ADDENDUM NO. 1

October 27, 2023

DPW Project No. 23-332
MIL: INTERIOR RENOVATIONS, BLACKFOOT READINESS CENTER
260 RICH LANE
BLACKFOOT, Idaho 83221

TITLE:
REVISED CONCRETE PAD

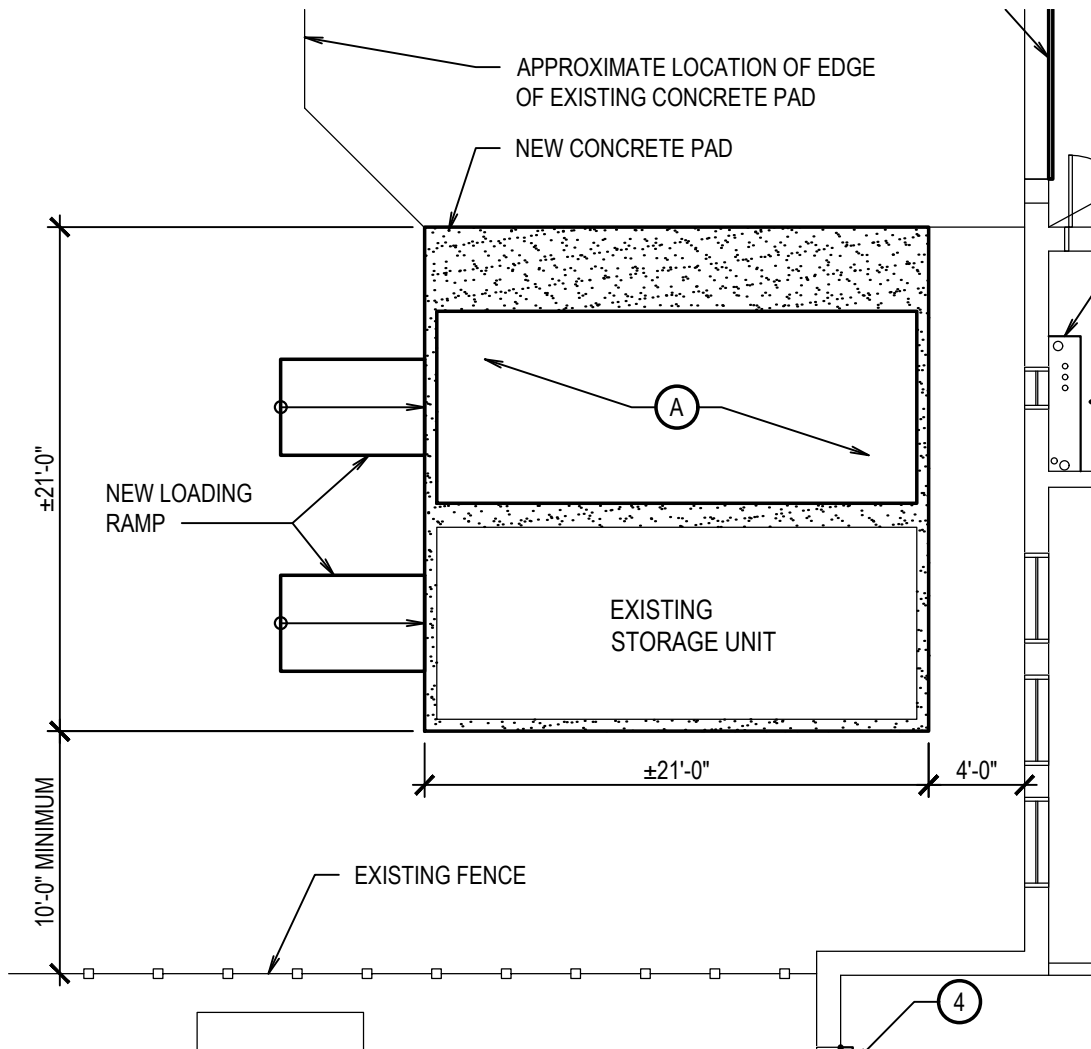
1. Plan Sheet A1.2, Keynote A: Conex box shall be 8' x 20' not 10' x 20' as shown.
2. Plan Sheet A1.2, Elevation C/A1.2. There is not any existing window tint that needs to be removed. See Specification Section 08 8700 "Architectural Window Film for type of new film required.

A. CONEX STORAGE UNIT SHALL BE 8'-0" WIDE x 20'-0" LONG, USED, OR NEW WITH LOCKABLE STEEL DOORS. PROVIDE SHOP DRAWINGS.

DOOR TYPES

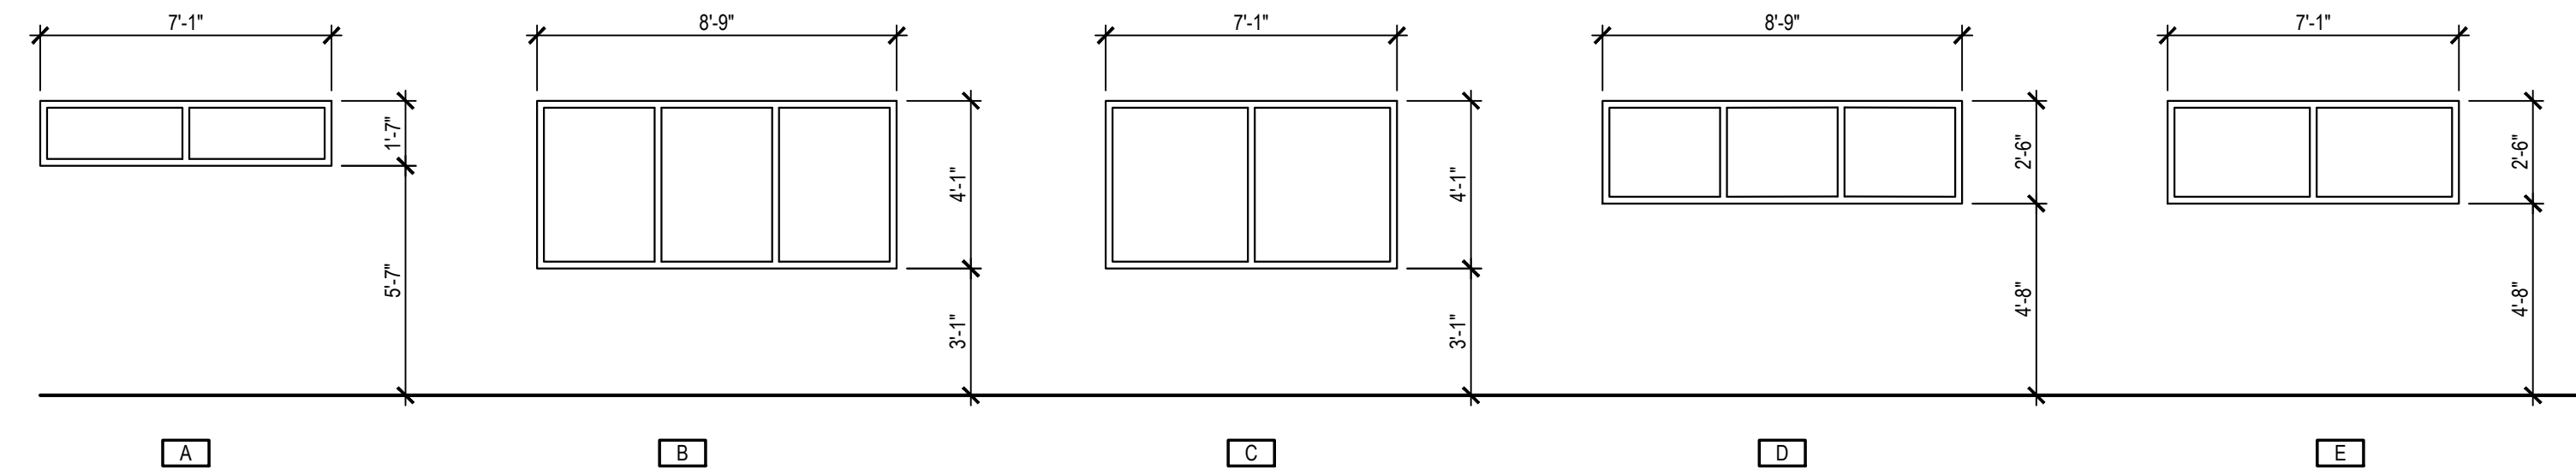
3. Plan Sheet A1.3, Door Type B - Change door slab height from 7'-2" as shown to 7'-0". Change HM frame height from 7'-4" as shown to 7'-2."
4. Range Hood: Quality Standard Broan 30-in, 190 CFM, Ducted, Stainless Steel Undercabinet mount or equal.

NEW REFLECTED CEILING PLAN

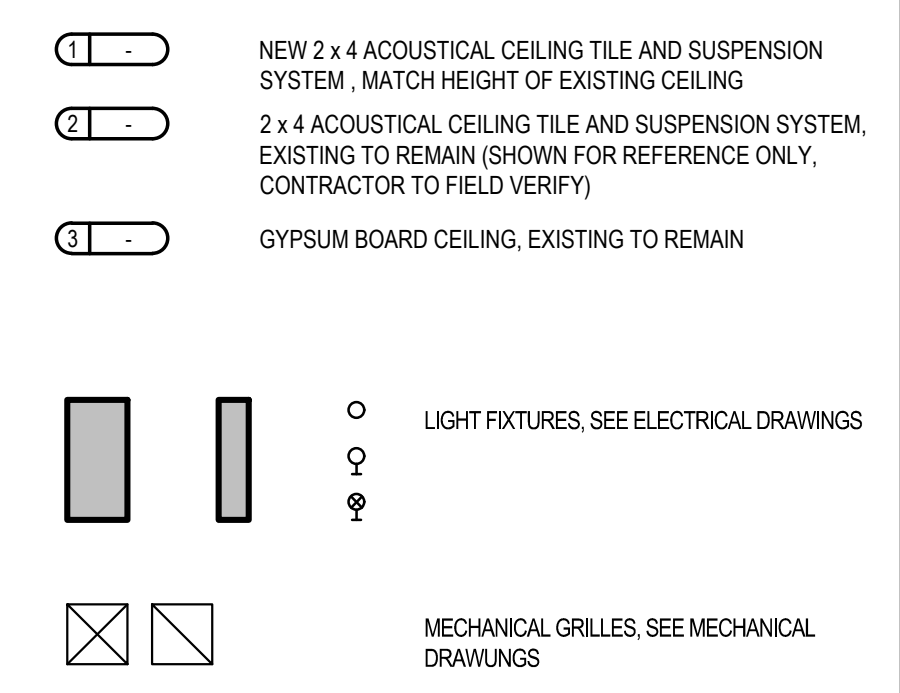
7. See revised Finish Schedule on sheet A1.4. When referring to the schedule please note the orientation of the north arrow in relationship to the building.
8. See revised Reflected Ceiling Plan on sheet A1.3. Existing gypsum board ceilings scheduled to be painted have been graphically modified for easier identification.
